SOUTH COAST AIR QUALITY MANAGEMENT DISTRICT

Draft Staff Report

Proposed Amended Rule 1118 – Control of Emissions from Refinery Flares

March 2024

Figure 2-7. Sulfur Dioxides Content from Clean Service Flares by Facility

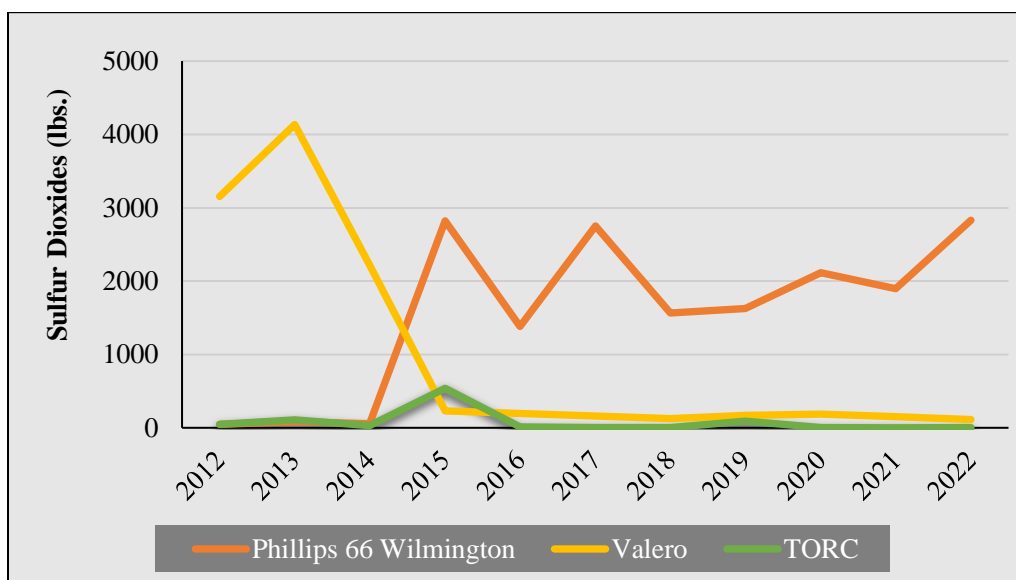
¹¹ While general service flares have higher total emissions and emit additional pollutants (like SO_x), Clean Service flares have significant emissions without much regulation. Also, clean service flares *do* contain some sulfur, particularly at Phillips 66 Wilmington, which included thousands of pounds per year of SO_x emissions from "clean service" flares.¹¹ Working Group Staff Report, Figure 2-7. Sulfur Dioxides Content from Clean Service Flares by Facility, p. 2-7

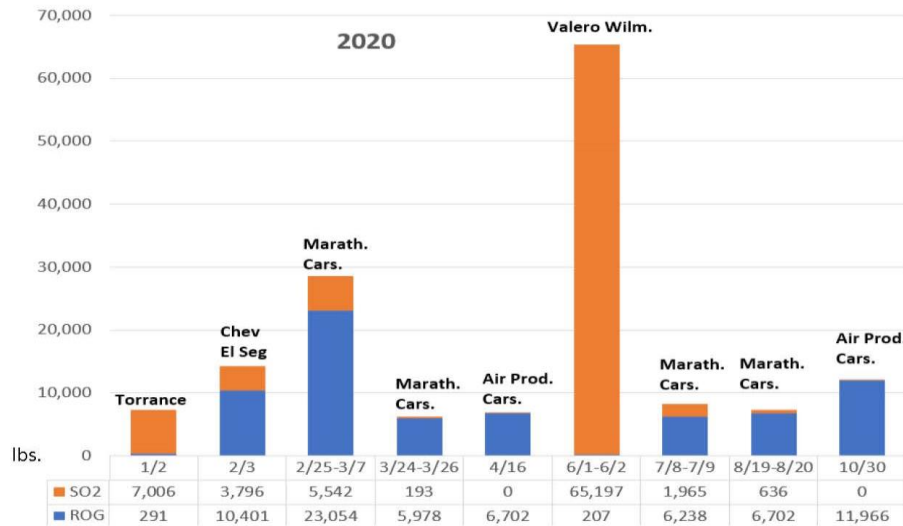
benzene. These emissions are not equally distributed across the region – they are concentrated in refinery towns - low income and communities of color.

Cont'd
3-2

In fact, AQMD’s AB617 CERP for Wilmington, Carson, West Long Beach found that the presence of several petroleum refineries caused the largest contribution of VOCs in this area.⁵

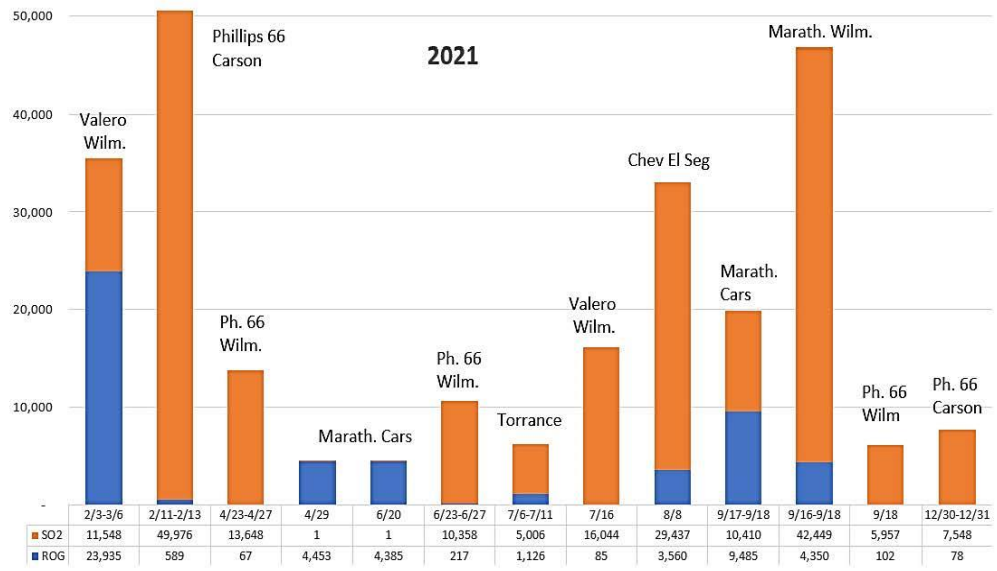
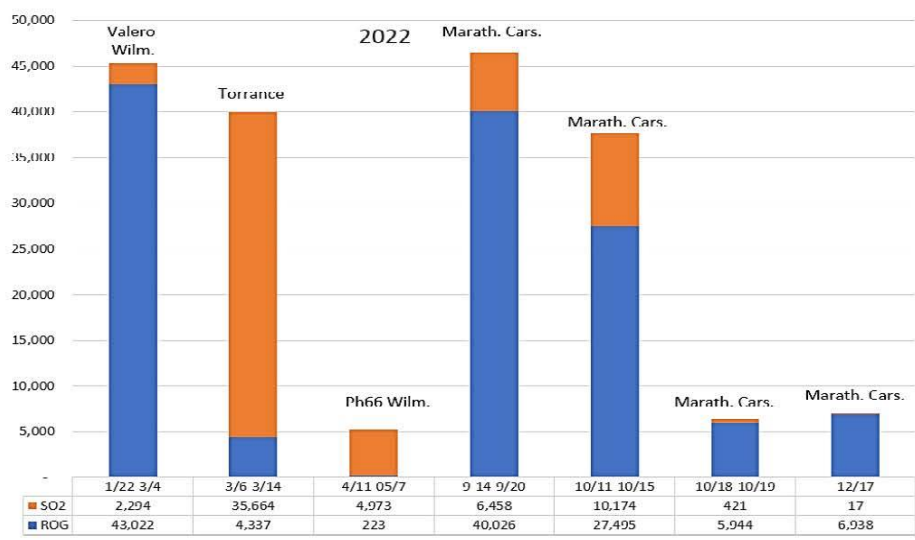
Cont'd
3-2

The charts above don't even show the full extent of the VOC flaring problem – only the largest events. **Frequent smaller events occur every year, adding up to hundreds of thousands of pounds.**

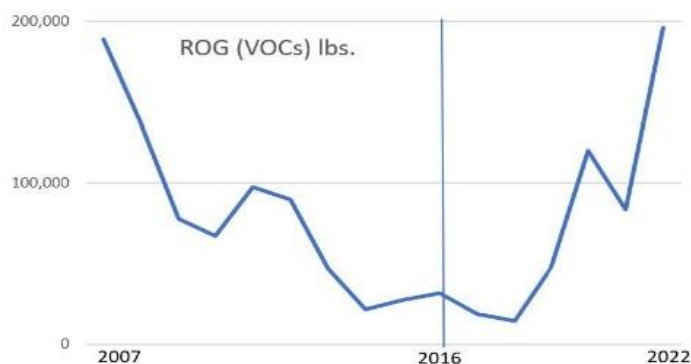
In addition to individual events, total annual emissions can be graphed. Based on aggregated quarterly data reports AQMD provides online, we charted the trend in total VOCs from flares over the years. (2016 is delineated because Torrance had particularly high flaring that year, with major Notices of Violation.) Note that after the 2017 flare rule update, some VOCs changed to higher emission factors. (EPA found flare destruction efficient not as high as assumed, resulting in higher emissions). Thus VOCs post-2017 are not directly comparable to previous years (which would have been shown even higher emissions.)

Cont'd
3-2

Regardless of changes in emission factors post 2017, the chart clearly shows that **past VOC flaring emissions were headed down, but in recent years VOC flaring emissions are headed up.** Total emissions are in the hundreds of thousands of pounds, concentrated in refinery communities.

We urge AQMD to apply to VOCs the same method used to chart tons of SOx per million barrels of crude oil at each refinery, each year (as in Table 3.3 shown earlier).⁶ This would identify the best annual VOC levels of the past, to help identify best practices toward lowering VOC emissions. (We could do the analysis ourselves with available data, but it would be helpful to have such a chart in AQMD's staff report, which includes many other valuable charts).

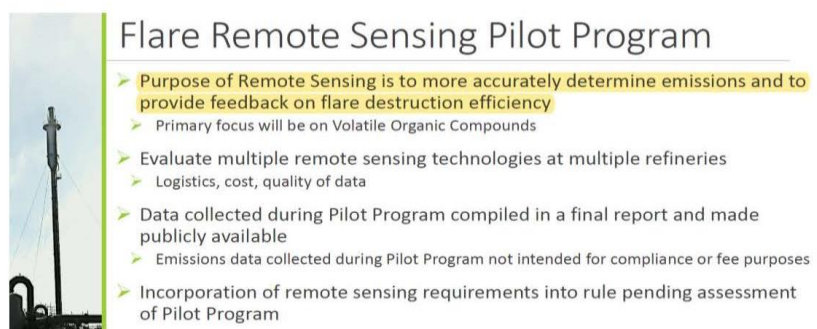
¹⁵ Methane has about 1020 BTU/scf, so 7 lbs/1,000,000 SCF / (1020 BTU/SCF) ≈ 0.007 lbs/MMBTU, and EPA’s factor for flaring methane is 0.66 lbs/MMBTU / 0.007 lbs/MMBTU = 94 times higher than the District factor.

This is another reason why specialized Remote Sensing of flares (discussed below) is needed. Especially for flares that operate almost continuously, the District would not have to wait for a flaring event to carry out the monitoring. The District should identify contractors who can perform this monitoring and at least begin pilot testing of flare destruction efficiency and actual VOC emissions.

Cont'd
3-6

Flare Remote Sensing Pilot Program

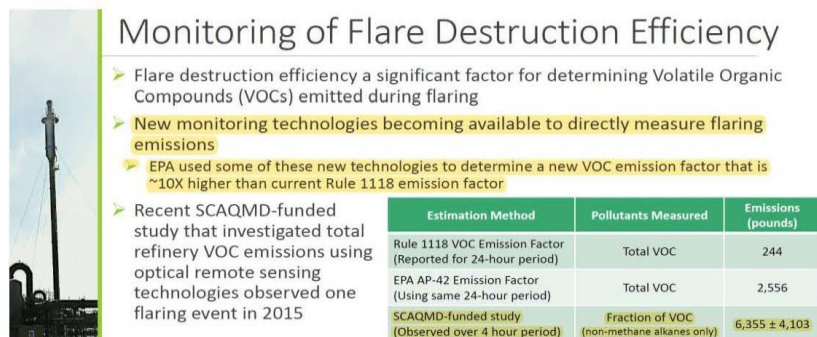
During the 2017 Rule 1118 update 2nd workshop, March 22, 2017, District staff presented the following slides 21, 22, and 23, which summarize Flare Remote Sensing well (highlights added) stating the "Purpose of Remote Sensing is to more accurately determine emissions and to provide feedback on flare destruction efficiency"

- Purpose of Remote Sensing is to more accurately determine emissions and to provide feedback on flare destruction efficiency
 - Primary focus will be on Volatile Organic Compounds
- Evaluate multiple remote sensing technologies at multiple refineries
 - Logistics, cost, quality of data
- Data collected during Pilot Program compiled in a final report and made publicly available
 - Emissions data collected during Pilot Program not intended for compliance or fee purposes
- Incorporation of remote sensing requirements into rule pending assessment of Pilot Program
